DUKE POWER COMPANY

October 17, 1984

Re: Catawba Nuclear Station
Docket Nos. 50-413 and 50-414

CATAWBA NUCLEAR STATION
DEVIATIONS FROM GENERIC EMERGENCY RESPONSE GUIDELINES

Figure 4.9-1. RVLIS System

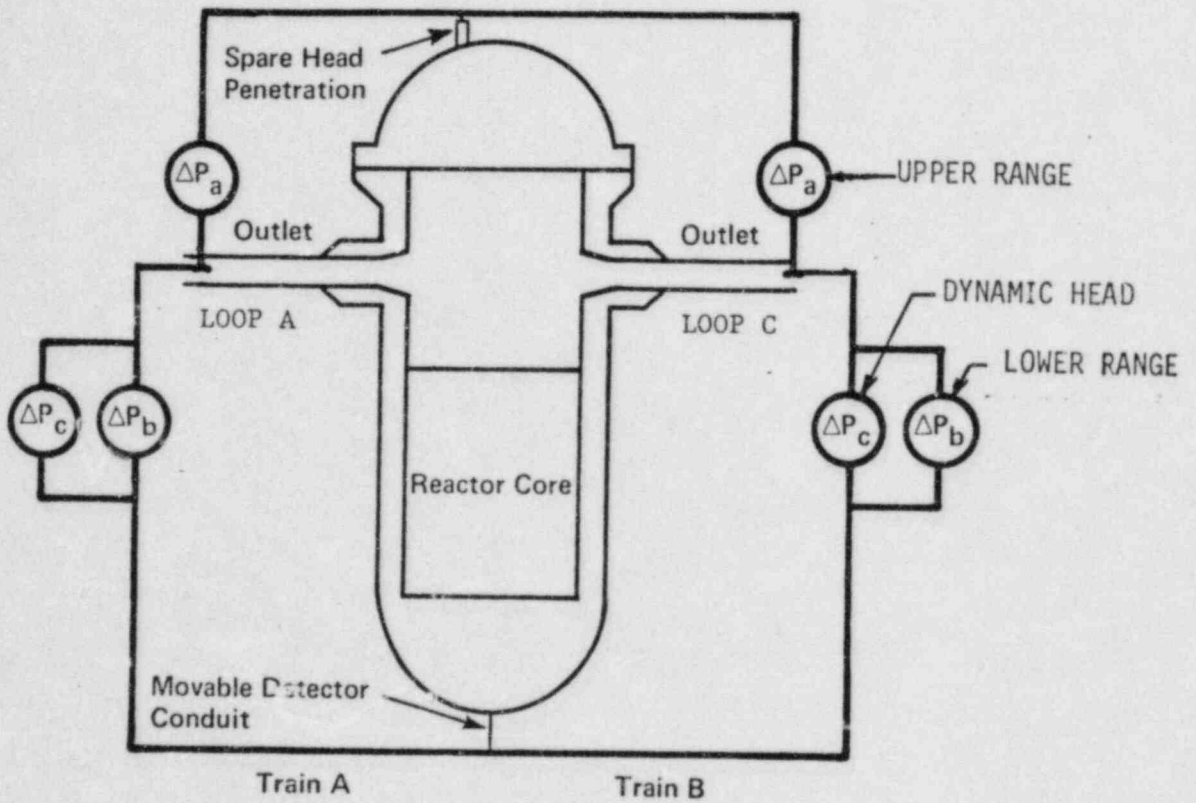
NRC CONCERN

THE RVLIS UPPER RANGE IS NOT USED IF ANY REACTOR COOLANT PUMPS ARE RUNNING, ALTHOUGH SOME CAPABILITY TO DO SO EXISTS.

BASIS FOR NOT USING RVLIS UR WITH RCPS ON

- THE RVLIS CHANNEL IS NOT VALID IF THE RCP IS ON IN THE LOOP WITH THE RVLIS TAP
 - CHANNEL A NOT VALID IF RCP A IS ON
 - CHANNEL B NOT VALID IF RCP C IS ON

- THE UR INDICATION VARIES DEPENDING ON THE NUMBER OF RCPS RUNNING AND TO SOME EXTENT ON THE COMBINATION OF PUMPS RUNNING
- THE DEPENDENCY OF THE RVLIS INDICATION ON THE RCP STATUS SIGNIFICANTLY COMPLICATES THE USE OF IT, IN PARTICULAR IN TERMS OF HUMAN FACTORS. THE USE OF THE RVLIS DHR ALSO DEPENDS ON THE RCP STATUS - HOWEVER ITS USE IN THAT MODE IS NECESSARY FOR ICC MITIGATION. (SEE NEXT PAGE)

- IT IS UNLIKELY THAT A PLANT TRANSIENT WILL EVOLVE INTO THE CONDITIONS OF CONCERN, I.E. RCPS RUNNING WITH A LARGE NONCONDENSIBLE VOID. THIS WOULD ONLY OCCUR DUE TO AN ICC EVENT. THE EPGs WILL NOT RESTART A REACTOR COOLANT PUMP IF A VESSEL HEAD VOID IS NONCONDENSIBLE. THE VOID IN THAT CASE WOULD BE VENTED PRIOR TO RCP RESTART.

- FOLLOWING AN ICC EVENT THE HEAD VOID WOULD NOT BE VENTED WITHOUT CONCURRENCE FROM THE TSC. UTILIZATION OF THE UR WITH RCPS ON COULD BE CONSIDERED AT THAT TIME

- *LOW OPERATOR CONFIDENCE*
- *LITTLE OPERATIONAL EXPERIENCE WILL BE GAINED IN THE AREAS OF INTEREST*
- *THE EXISTING METHOD PROVIDES ALREADY FOR A LEVEL OR VOID FRACTION INDICATION UNDER ANY CONDITIONS*
